PCN – Product Change Notification

PCN-A-120605

PCN Topic: The power supply of 32" A2 panel (1920x1080) will be changed from external 216W AC to DC adapter to built-in power.

Old Open Frame Mechanical Design (32" A2):

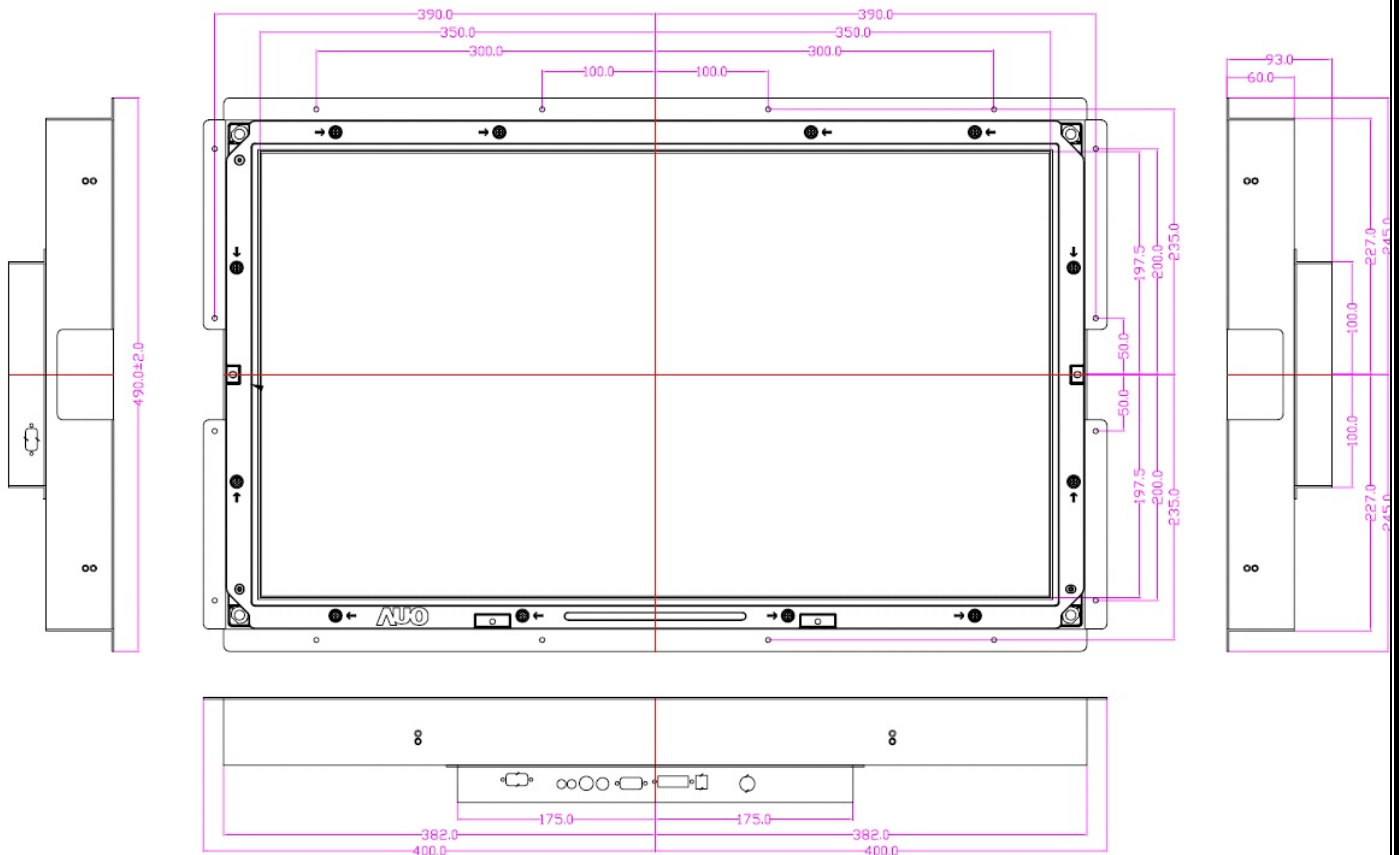
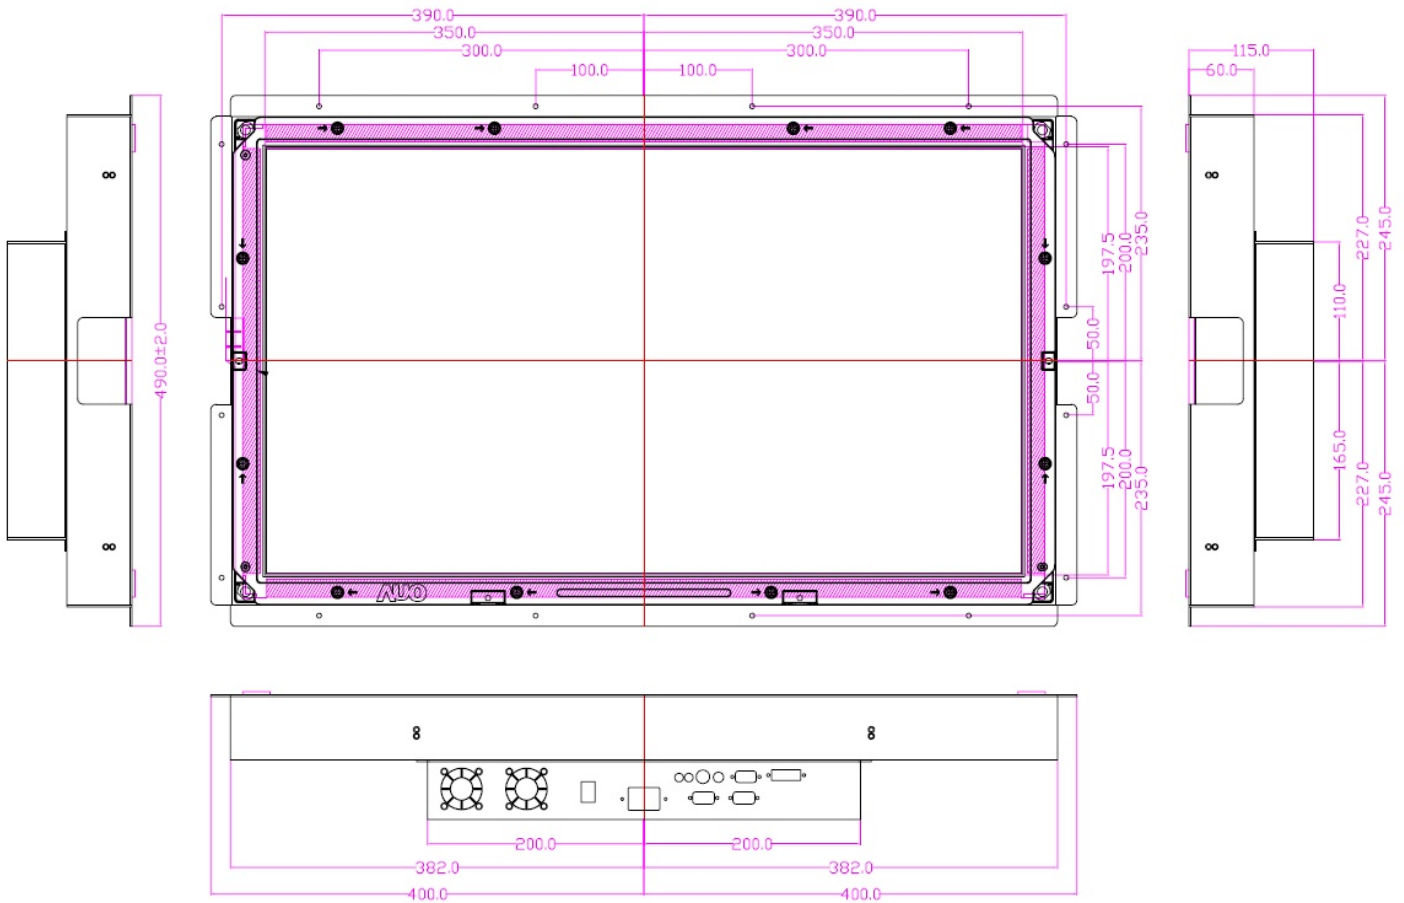
The dimension of **Open Frame** mechanical will change from **800 X 490X 93** mm to **800 X 490 X 115** mm.

Old Chassis Mechanical Design (32" A2):

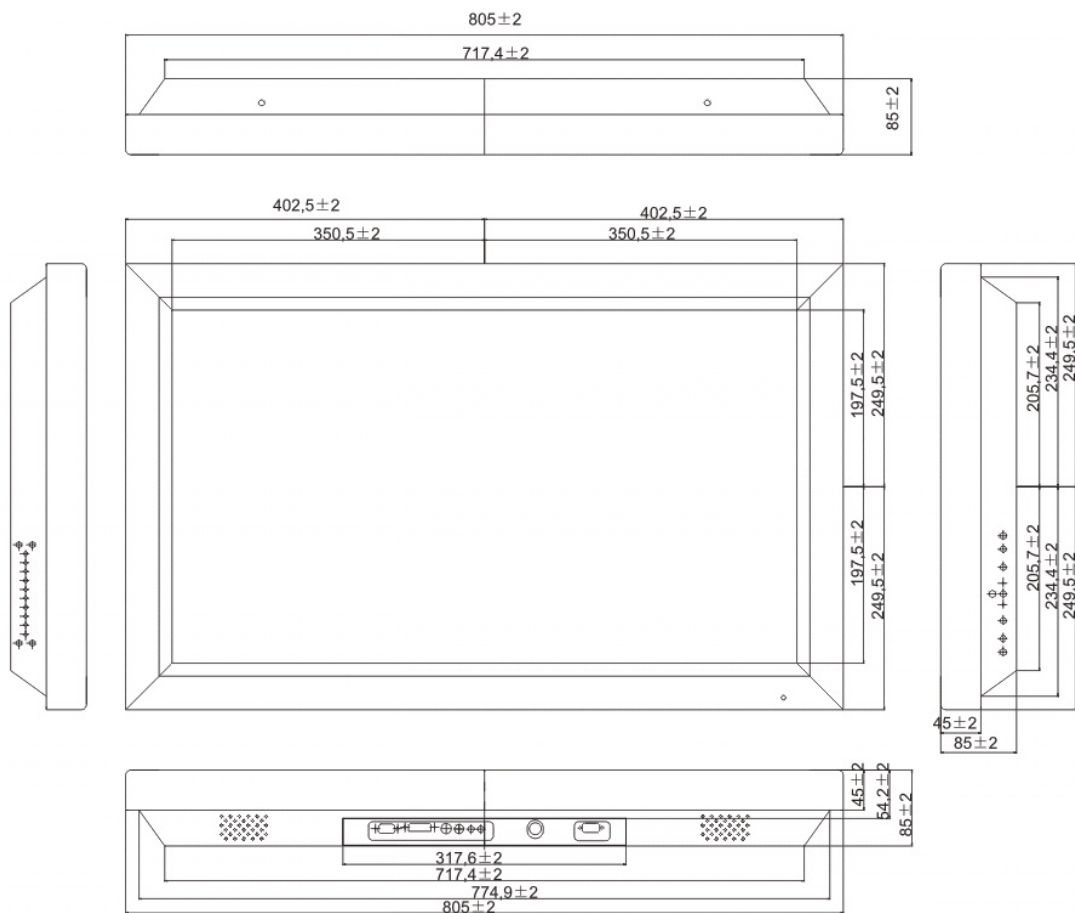
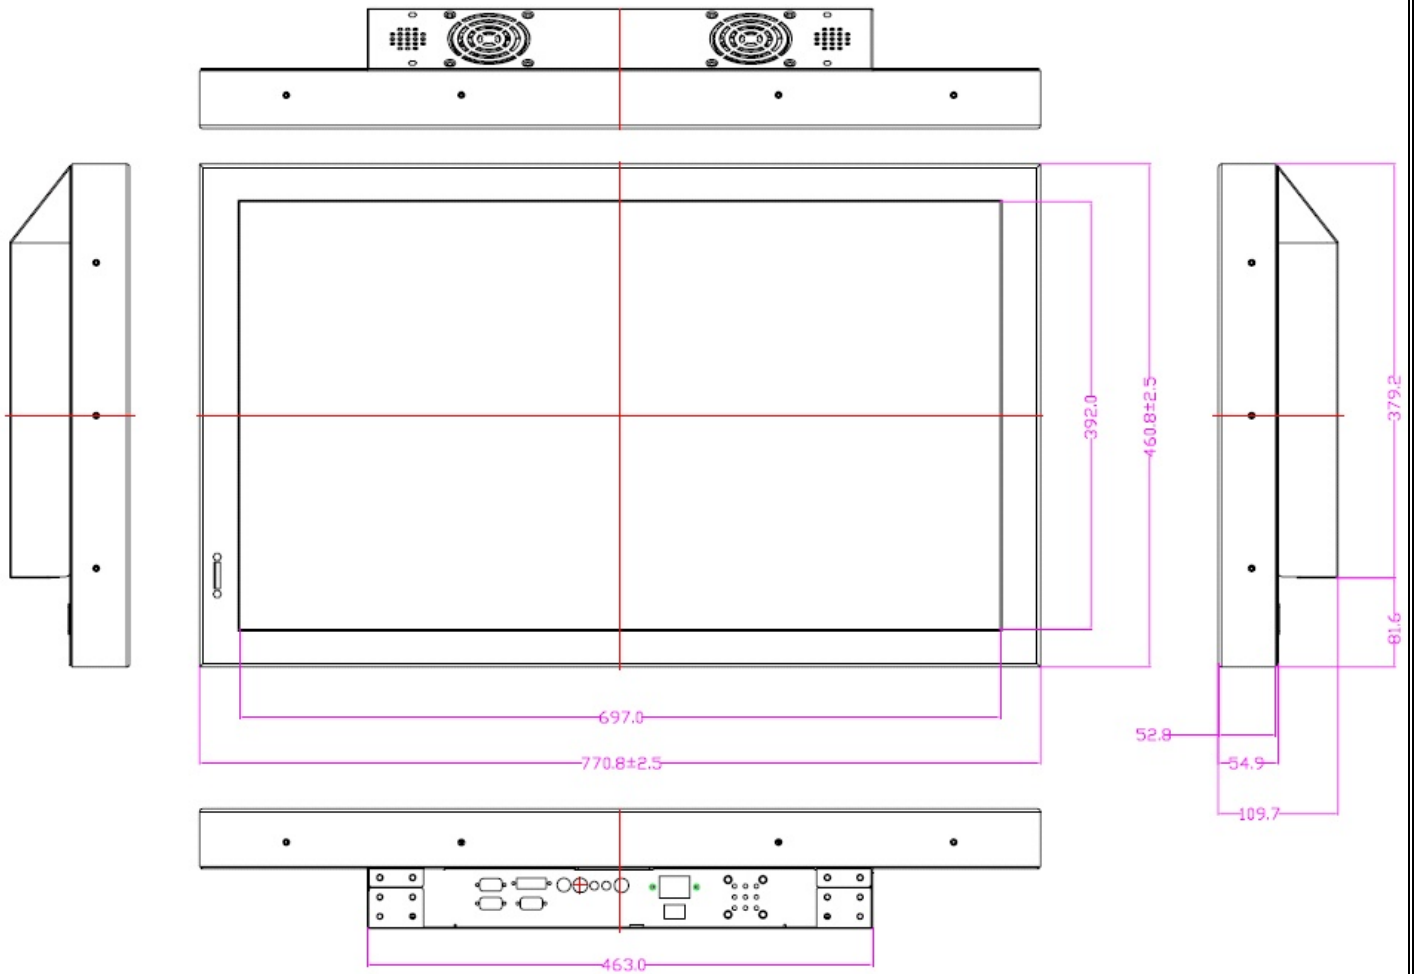
The dimension of **Chassis** mechanical will change from **805 X 499X 85** mm to **770 X 460.8 X 109.7** mm.
